MEMORANDUM

Date: 18 August 2025

Subject: Proposed Bay of Islands Marina Precinct and Mixed-Use Zoning and Mixed Use Zoning.

Ref #: 25061_01

Plate 1. Opuia Settlement Extents (reproduced from Urban Design Evidence).

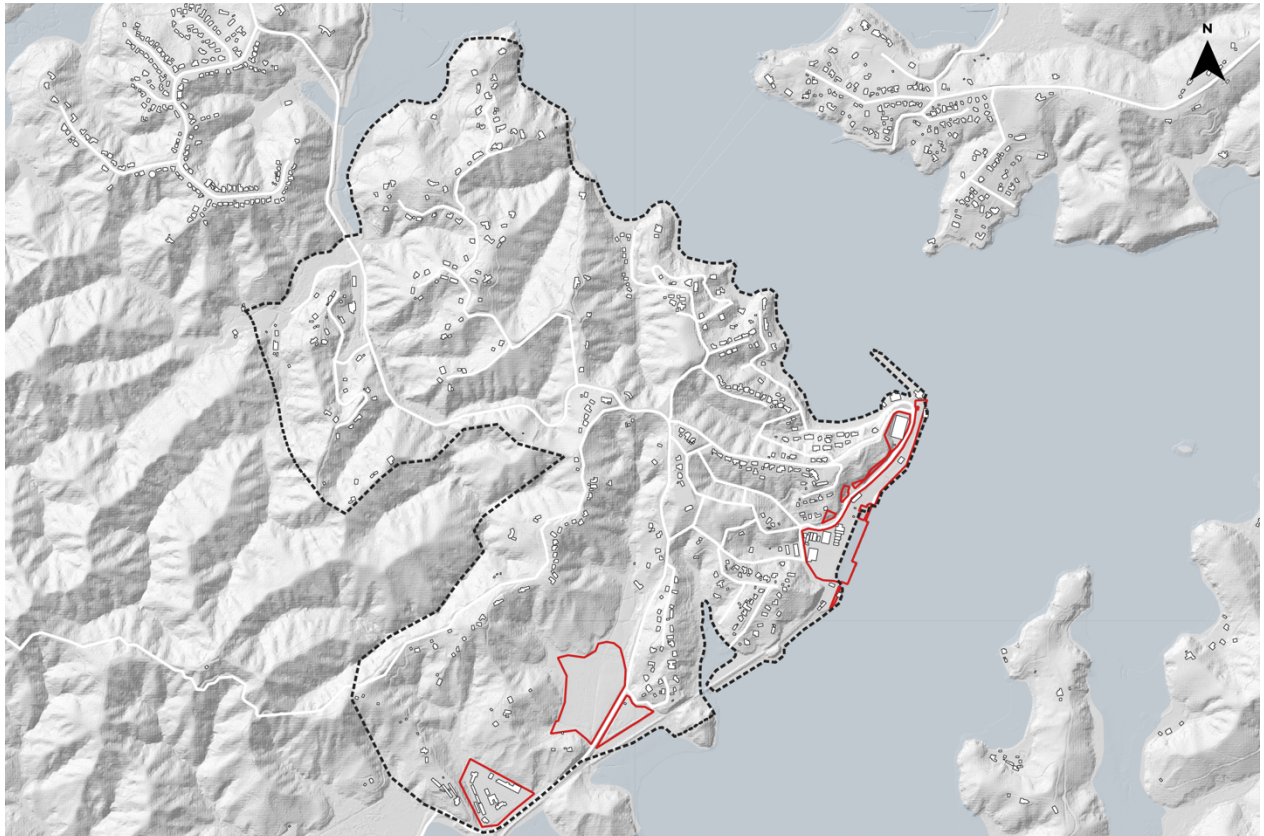
Mr Lonink argues that his analysis shows that the urban extent of the Opuia Settlement does not fully align with the proposed zoning.

The approach to assessing the urban extent of the Opuia settlement adopted by John Lonink has been to evaluate lot size and built density. In my view this is a little misleading. My perception of the character of the Opuia settlement is based on observation of landscape character and is principally informed by the relationship of built form to the topography and vegetation patterns.

Figure 1 in my attachments is a modified version of Figure 5 of Appendix 1(attached to the evidence of John Lonink). This figure illustrates how the settlement pattern of Opuia are strongly influenced by the terrain, with dwellings constructed along, or close to the ridge crests, whilst the intervening gulleys are retained in native vegetation. Generally, dwellings have located to benefit from views to the Bay, Veronicas Channel or Waikare Inlet and this is reflected in the large proportion of dwellings being located on ridges and spurs to the east of the main north – south aligned catchment boundary ridge. Where dwellings are located to the west of this ridge, these often 'sneak' views to the water, or are elevated sufficiently to gain distant views (such as properties along Oromahoe Road).

FIGURE 1: Landscape Context

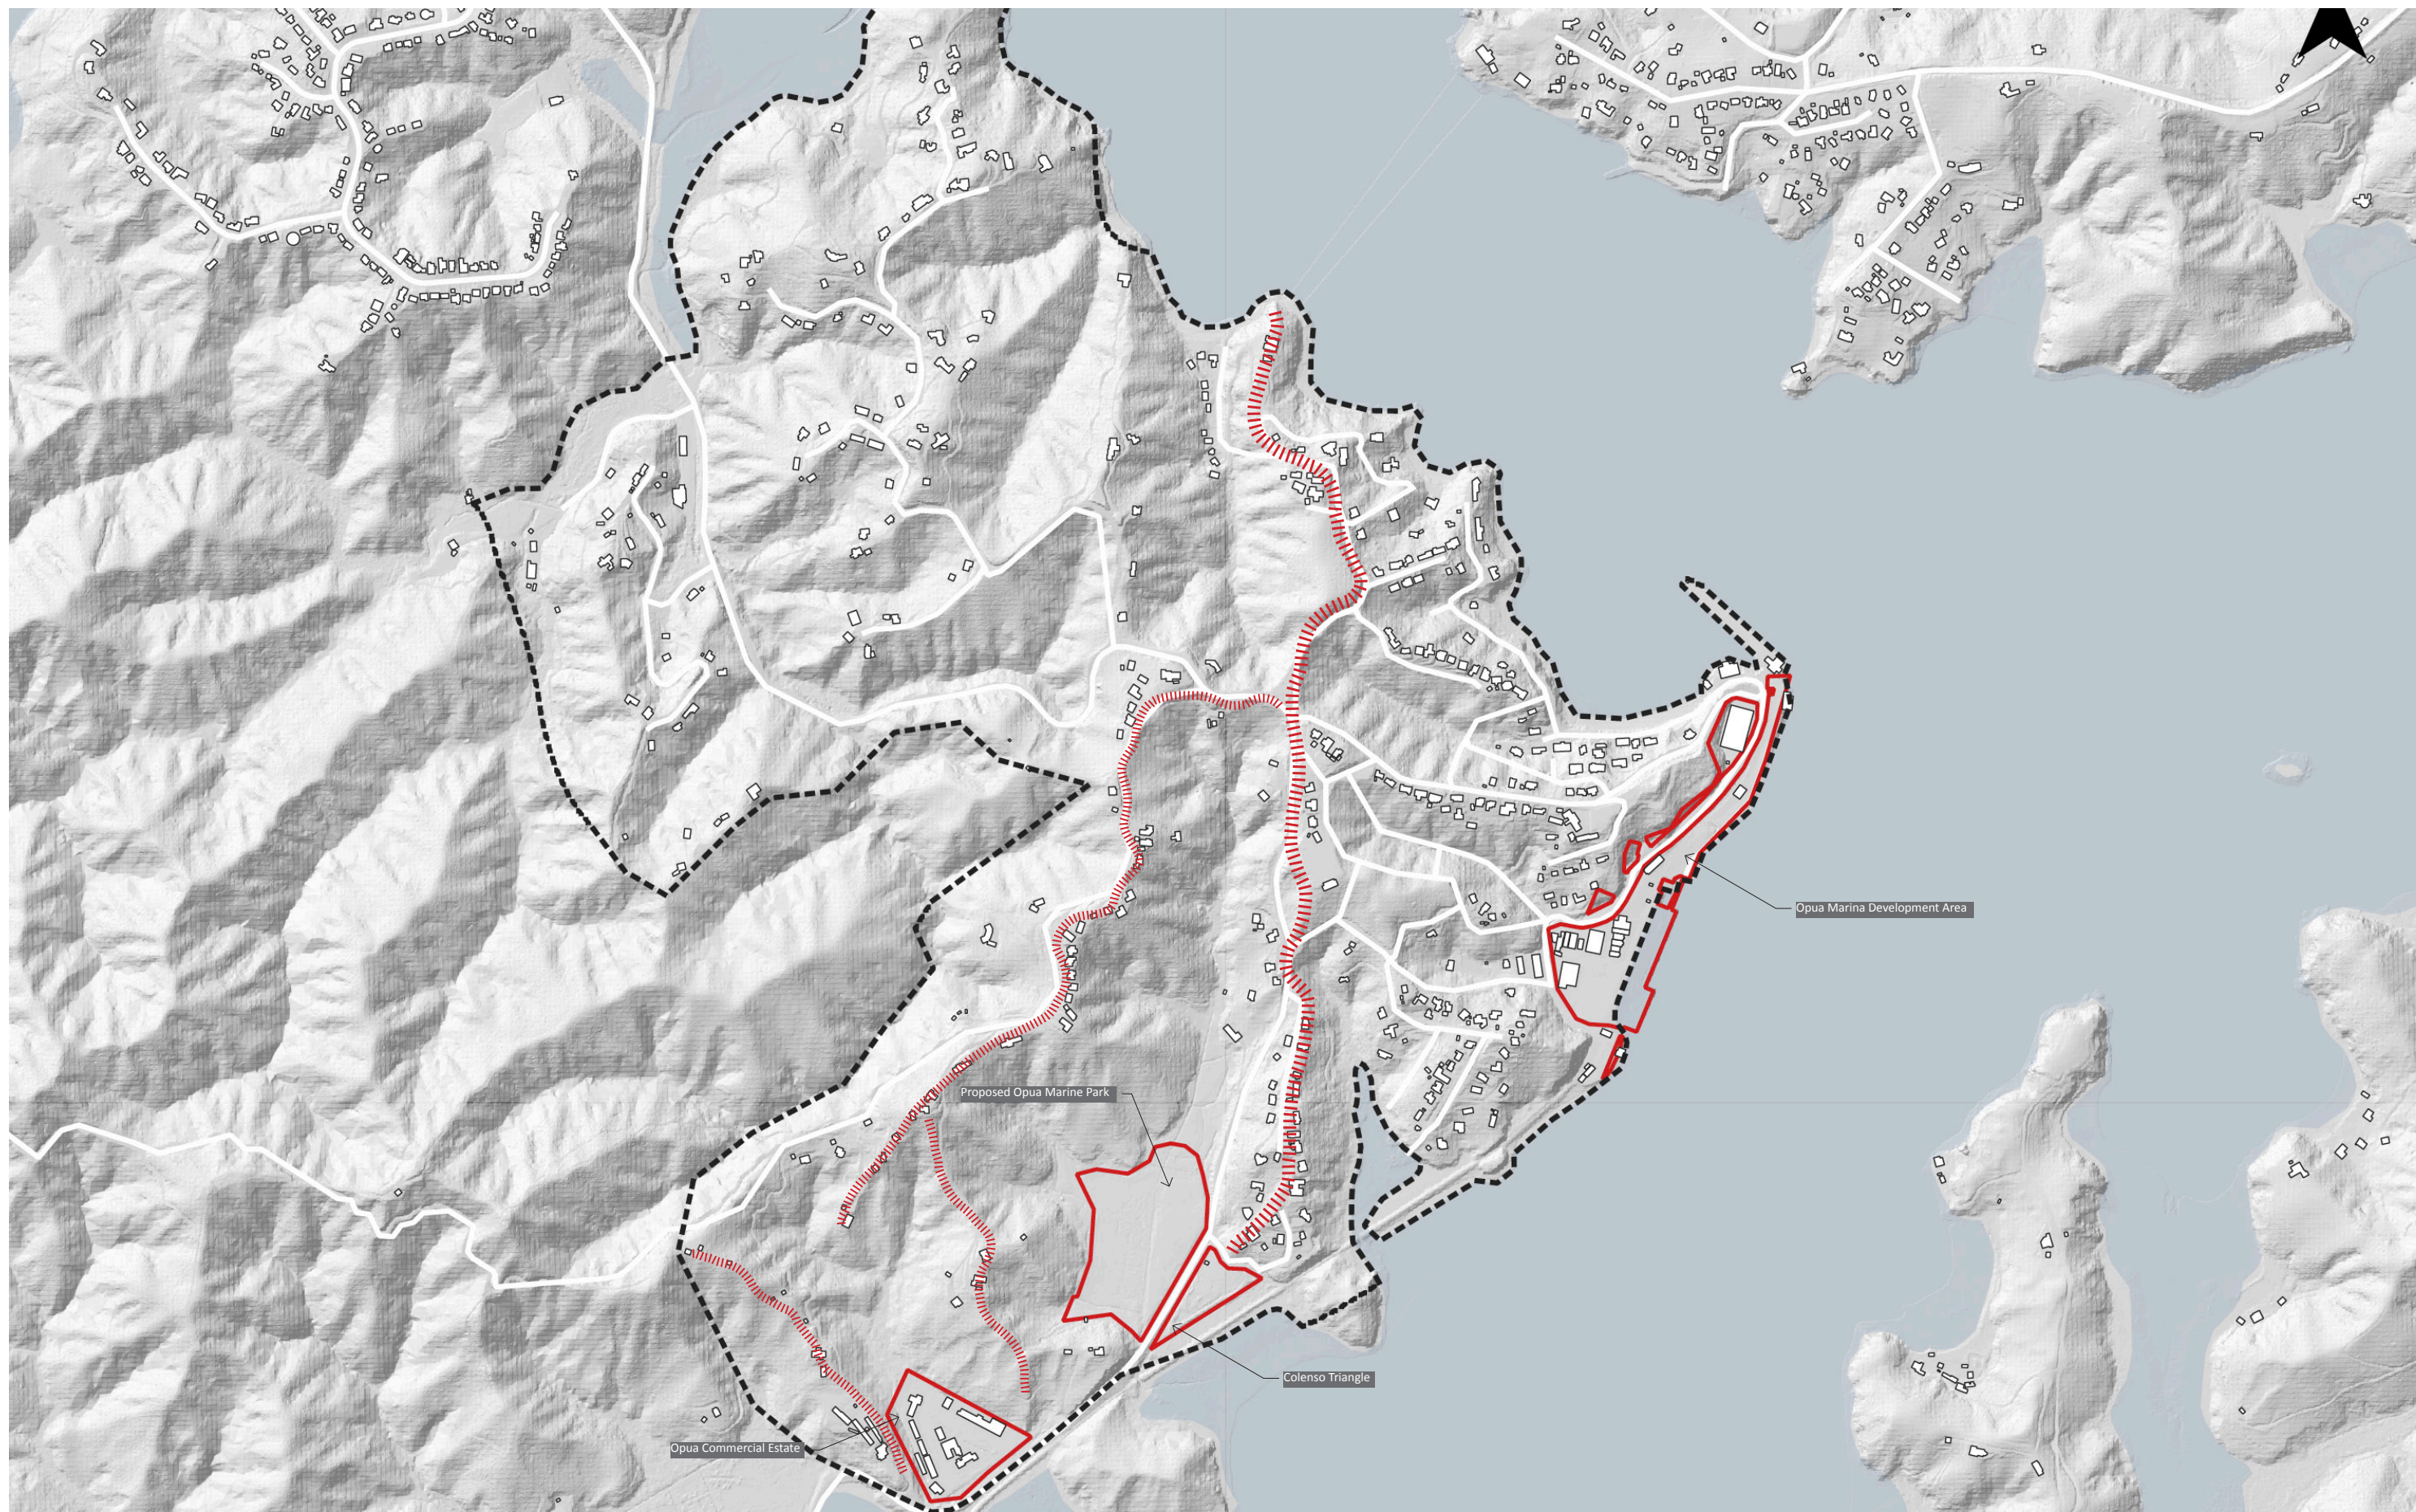
This area of development is contained by spurs on its western and eastern sides (refer to Figure 1). Located on the western spur, a motel complex (Pine Lodge) is elevated above, but is largely hidden from the road.

steep valley sides, which rise to a height of some 60m, are for the most part vegetated with native forest and shrubland. Defined by the containing ridges as depicted in [Figure 1](#), the valley forms a discrete character area.

FAR NORTH HOLDINGS LIMITED
Proposed Bay of Islands Marina Precinct and Mixed-Use Zoning
 FIGURE 2b: Proposed Marine Park mitigation concept

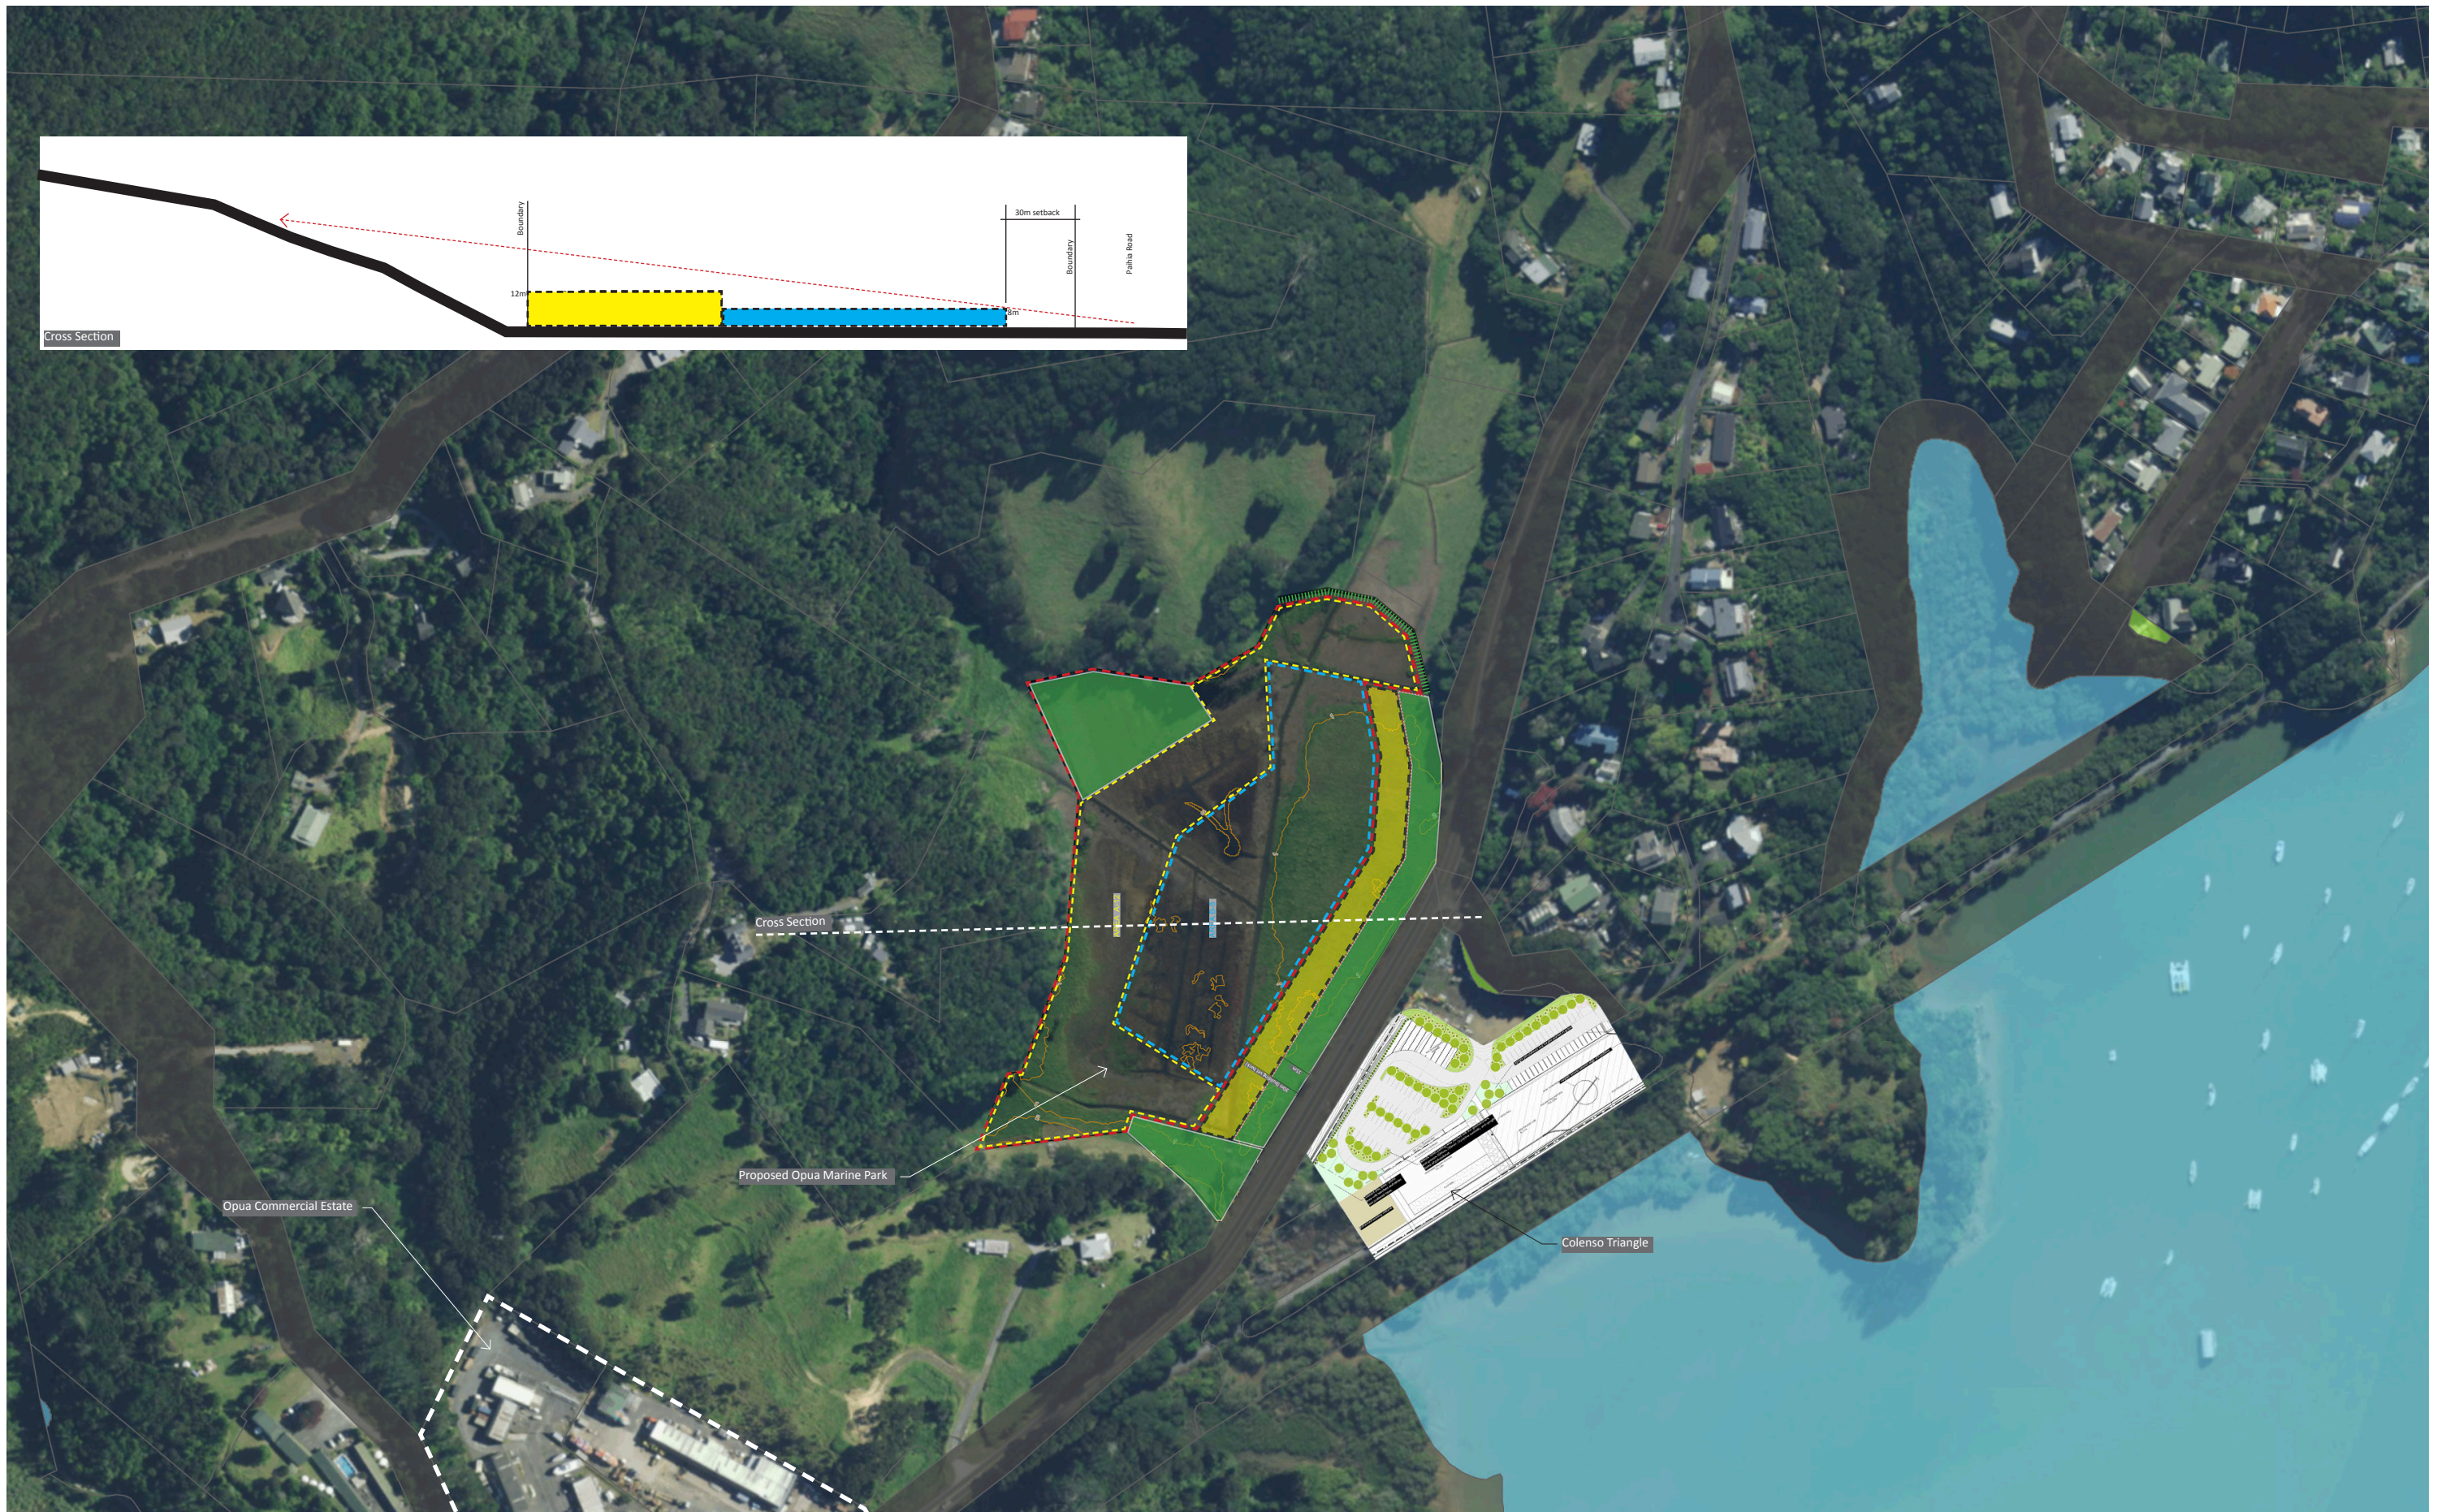
The Absolum memo has flagged a level of concern with this development:

“Development along the lines sought by FNHL would need very careful management to ensure appropriate mitigation that successfully integrates any development into this more rural setting.”³

The preliminary proposal is that a suite of mitigation measures, partially facilitated via a conceptual development plan and development guidelines (refer to Figures 2b and 2c and Table 1 below), and also via modified standards for the MUZ (to be developed) be employed.

The development concept seeks to integrate future development into its landscape setting. The proposed development area occupies the majority of the valley floor to the west of State Highway 11. In conjunction with the consented development within the Colenso Triangle site, it will form a gateway development to Opua, and will be experienced in conjunction with the Opua Commercial Estate situated on the State Highway to the south west.
